Your Ref
BN/38/18/L
Our Ref
PLAN-024738
Date
17/10/2018

Proposal: Listed building consent for an annexe extension ancillary to the main dwelling.

Site: Parsonage Farm House, Lake Lane, Barnham, PO22 0JD.
BN/38/18/L

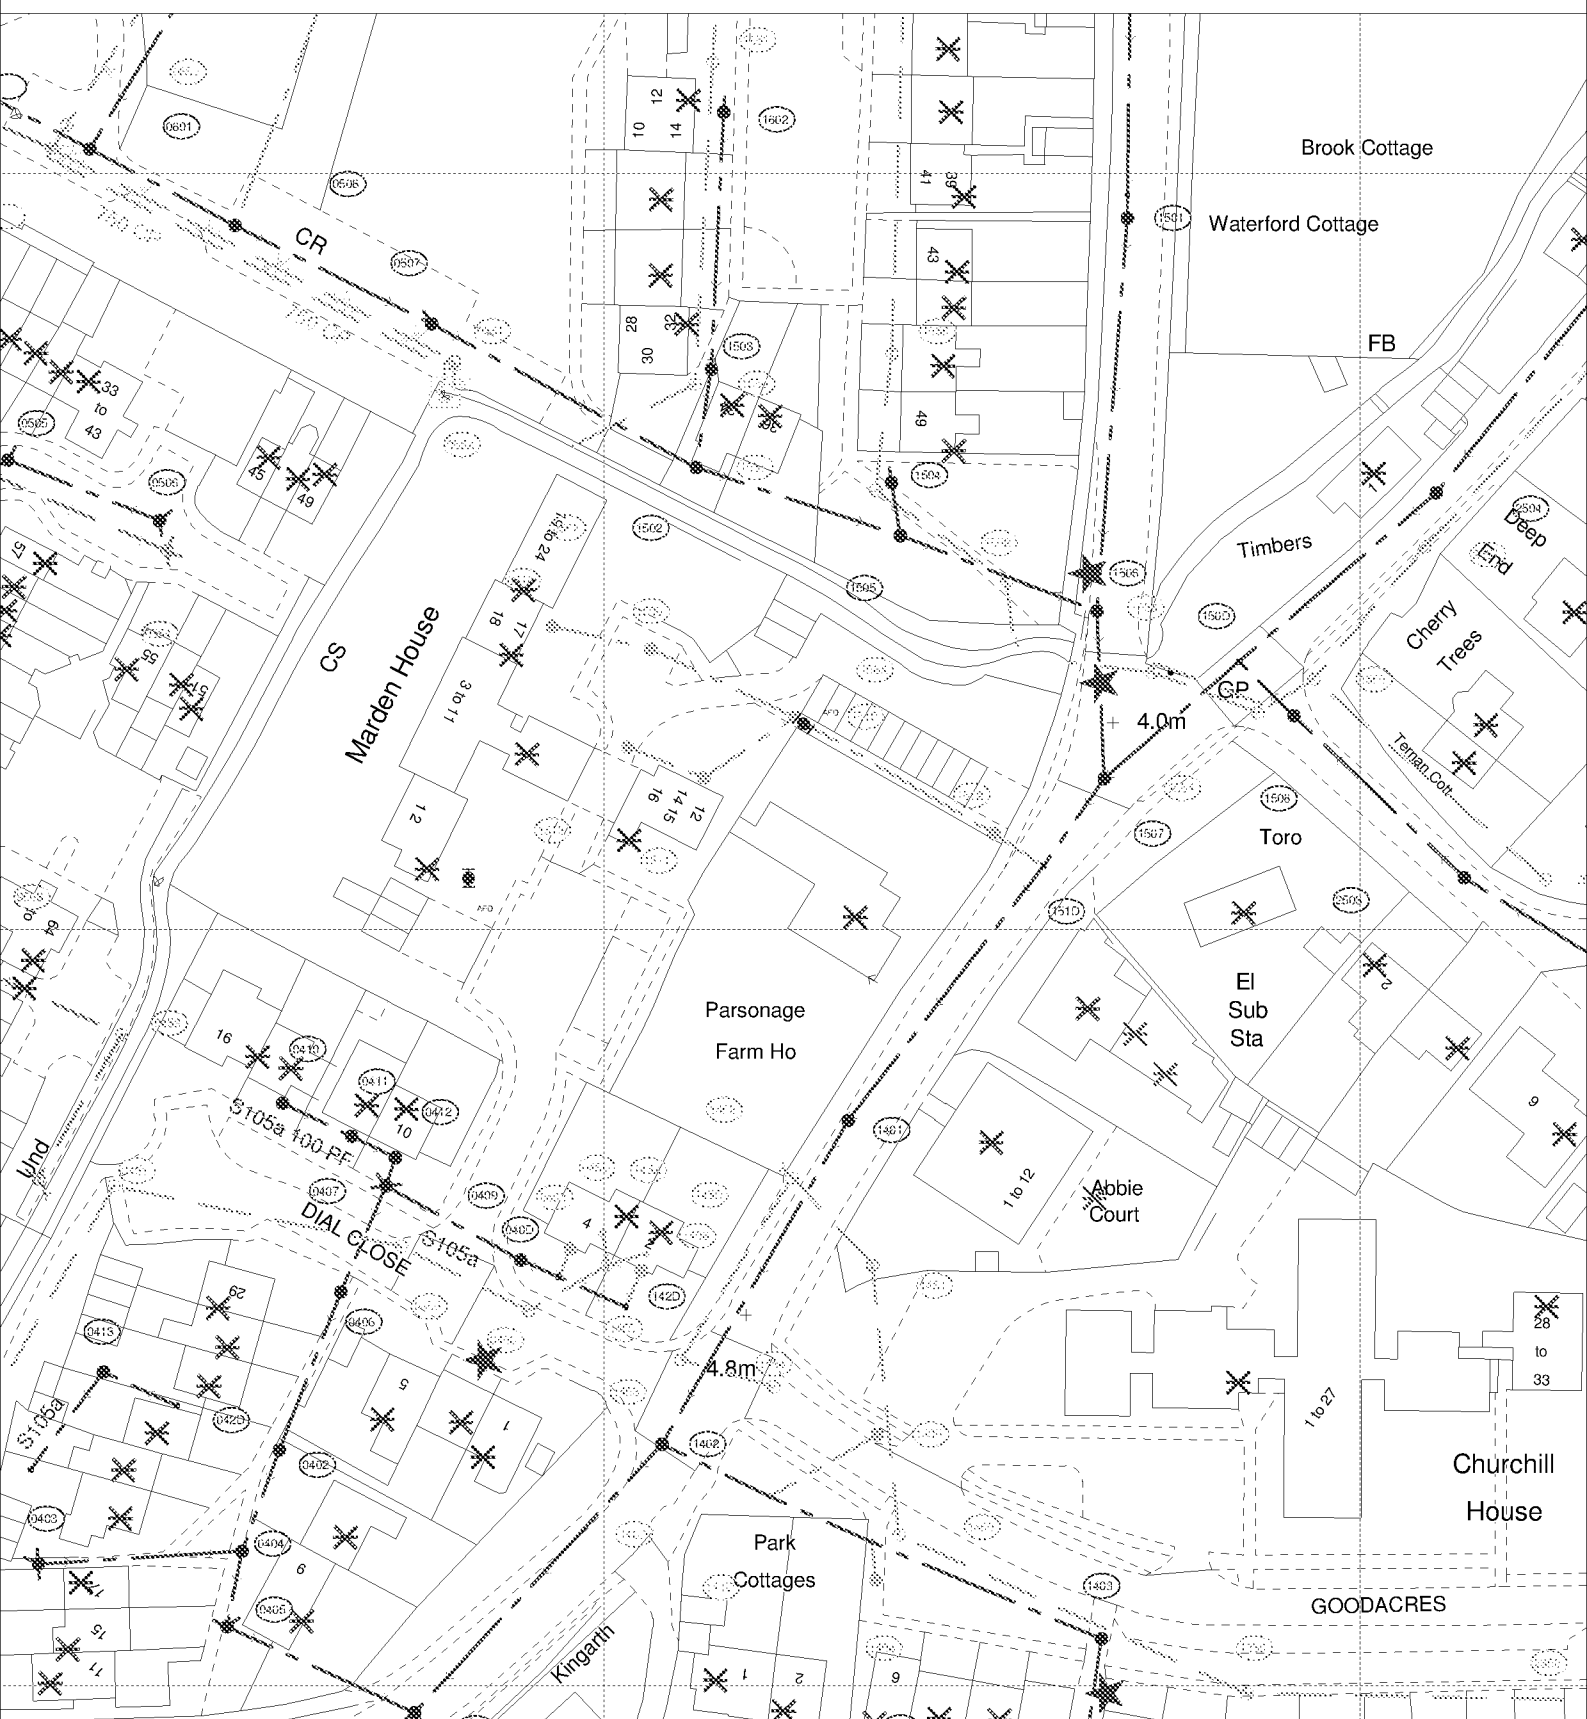
Due to surface water inundation issues in the Lidsey Catchment “The applicant is advised to adopt, where appropriate, the measures in the table “Practical measures to reduce the potential impacts of development”.

Developer should look to protect the public sewerage system from inundation and infiltration, which contribute to flooding in unfavourable conditions.
